## HIGHWAY WORK PROPOSAL

<u>COUNTY</u>	<u>STATE PROJECT</u>	<u>FEDERAL</u>	<u>PROJECT DESCRIPTION</u>	<u>HIGHWAY</u>
Milwaukee	2978-02-70	WISC 2021261	Silver Spring Dr; N Long Island Dr To N Lydell Avenue	LOC STR

Addendum No. 01  
ID 2978-02-70  
Revised Sheet 96  
March 22, 2021

Addendum No. 02  
ID 2978-02-70  
Revised Sheet 5  
April 2, 2021

Addendum No. 03  
ID 2978-02-70  
Deleted Sheet 137  
April 7, 2021

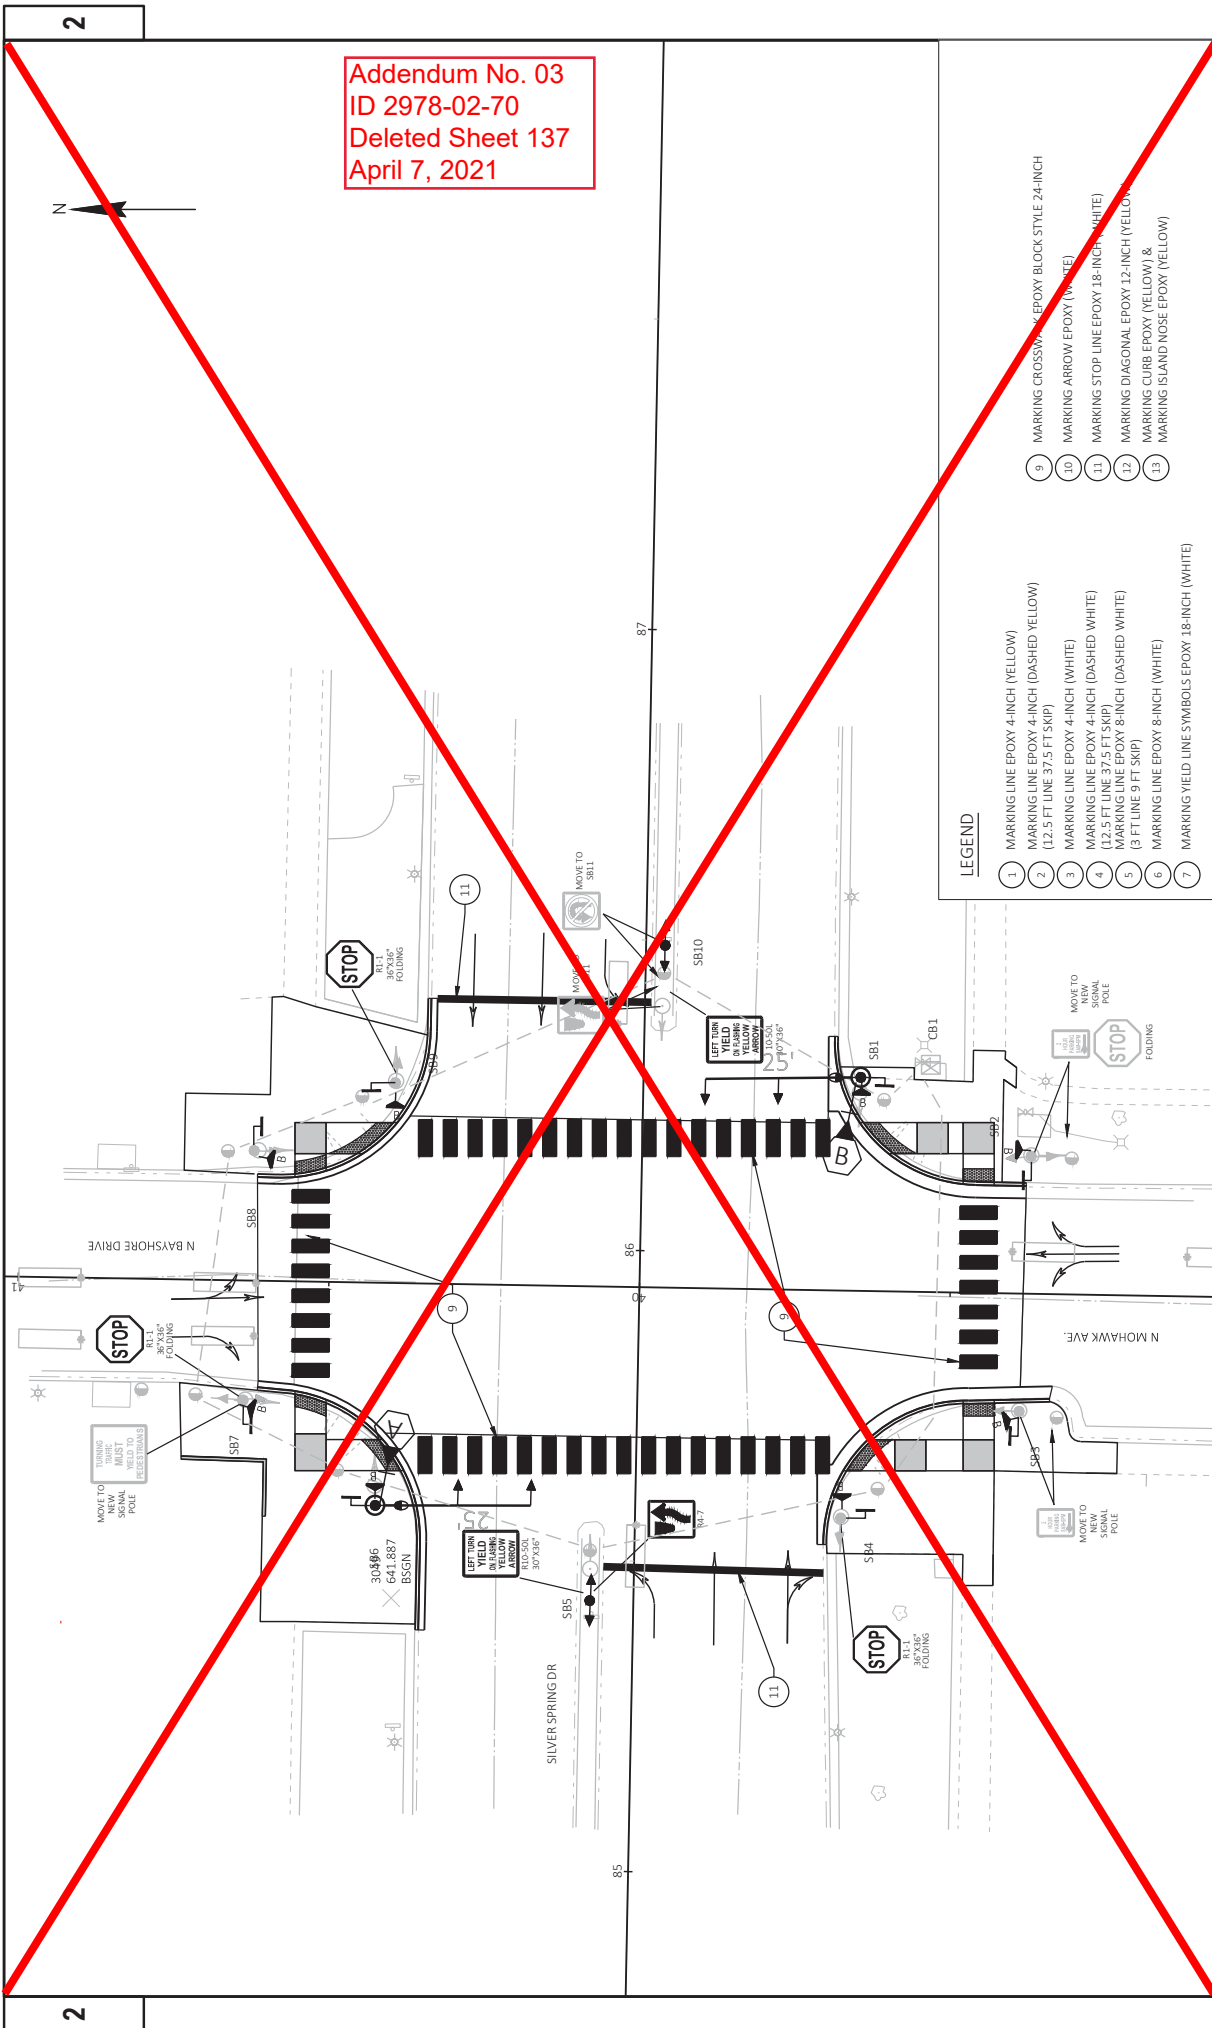
<b>Deleted Plan Sheets</b>	
Plan Sheet	Plan Sheet Title (brief description of changes to sheet)
137	Pavement Marking And Signing – duplicate of Sheet 135
